<Response to Referee #2>

We thank the reviewer for carefully reading our manuscript and for providing important comments. We address the comments below. Our responses are in bold and red in the supplement version. Updated figures are included in the supplement PDF file.

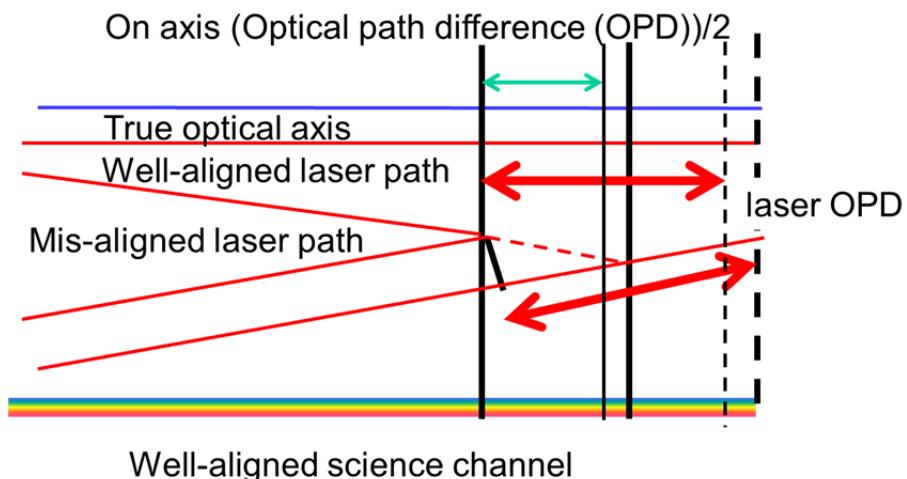
(39) Page 2985, lines 9-10 state: "Because all the bands of 1, 2 and 3 have the constant wavenumber shift, the most probable cause is the optical alignment change of the laser beam on orbit". Comment: A change in the alignment of the laser beam would cause a shift that was proportional to wavenumber (i.e., a stretch), not constant.

(40) Page 2985, lines 10-12 state: "...the most probable cause is the optical alignment change of the laser beam on orbit as illustrated in Fig. 11. Consequently, MODP has become larger and spectral resolution has become slightly higher." Comment: I'm struggling to reconcile this statement with figure 11, which illustrates that the misaligned laser OPD is *shorter* than the well-aligned laser path. Since the MODP actually got *larger*, does this mean that the laser alignment has improved since the start of the mission?

A: No. As the laser is the standard of FTS system, the laser path length (which is the laser wavelength multiplied by total number of fringes) is the same even if the laser alignment changes. The laser alignment becomes worse since the start of the mission. To avoid the confusion, we have modified Fig. 11.

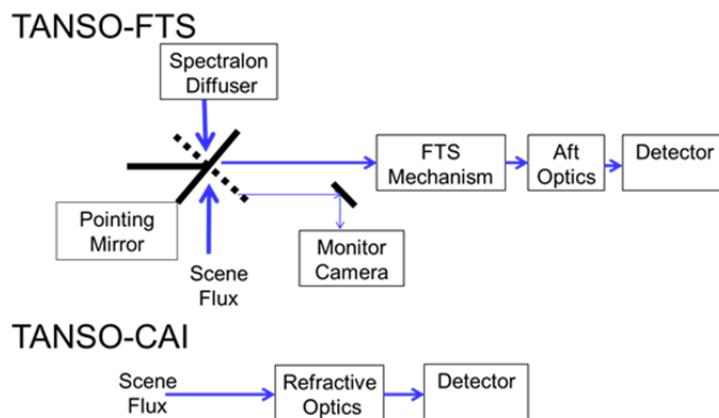
(52) Page 3003, Figure 1: Suggestions: Add blue arrow from Spectralon Diffuser to Pointing mirror. Change "After Optics" to "Aft Optics".

A: We have modified Figure 1 as follows.

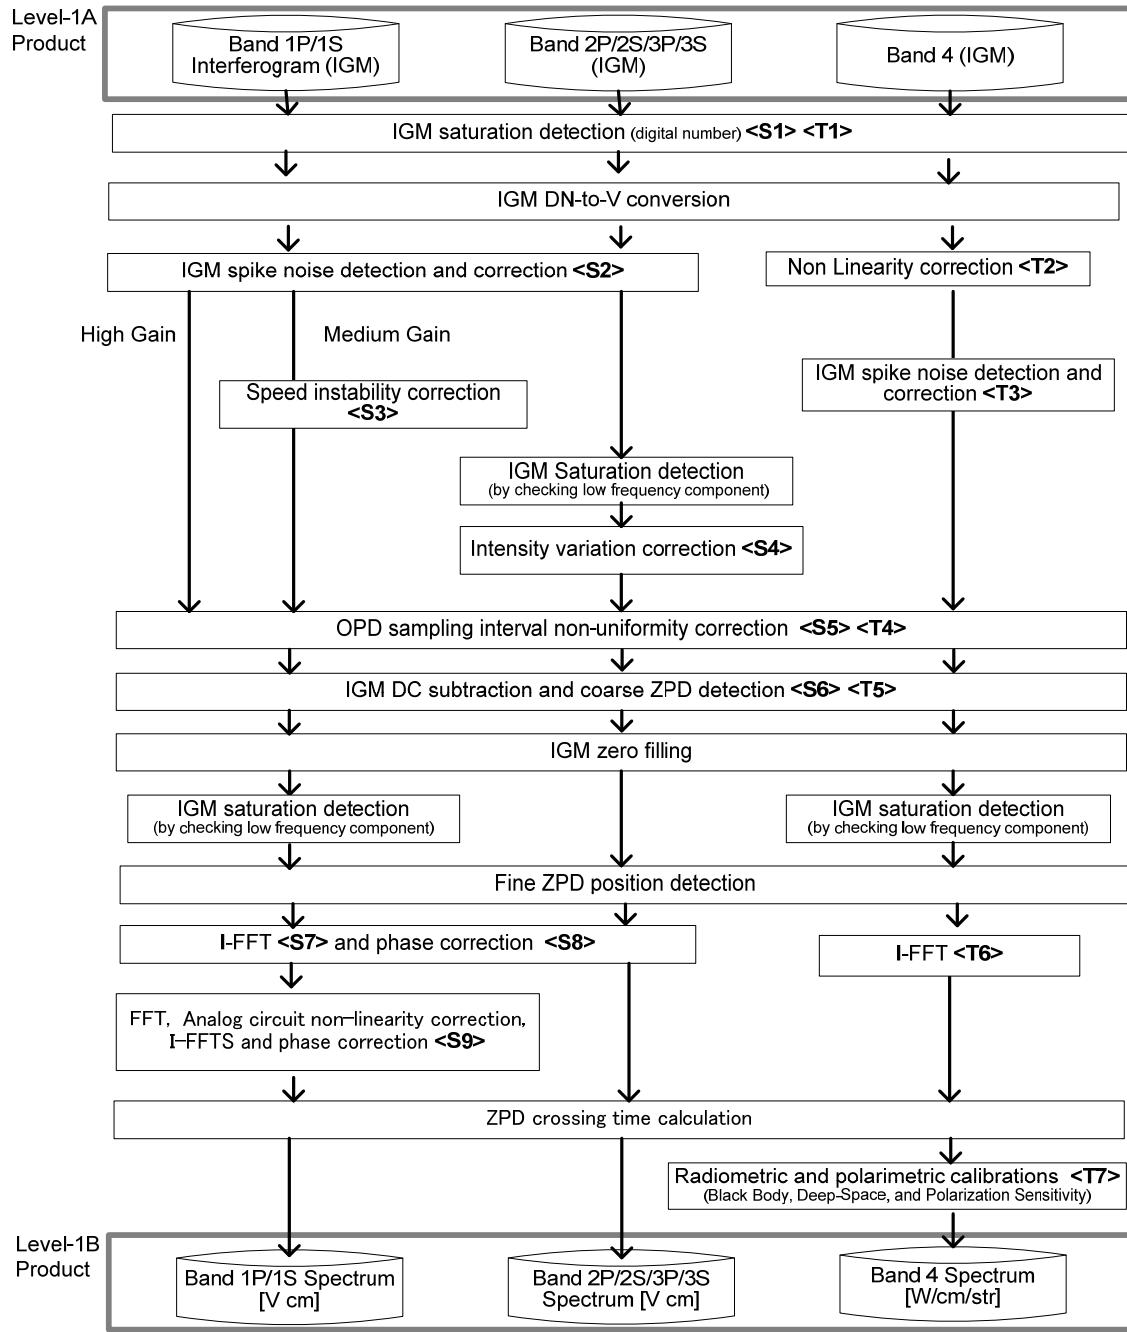
(53) Page 3005, Comment: In Figure 3 the spectral radiance units are denoted as “V/cm⁻¹”. Elsewhere in the paper the units are denoted as “V cm”, which is the same thing, but in my opinion less intuitive. You should express the spectral units consistently throughout the paper.

A: We have modified Figure 3 and Table 2
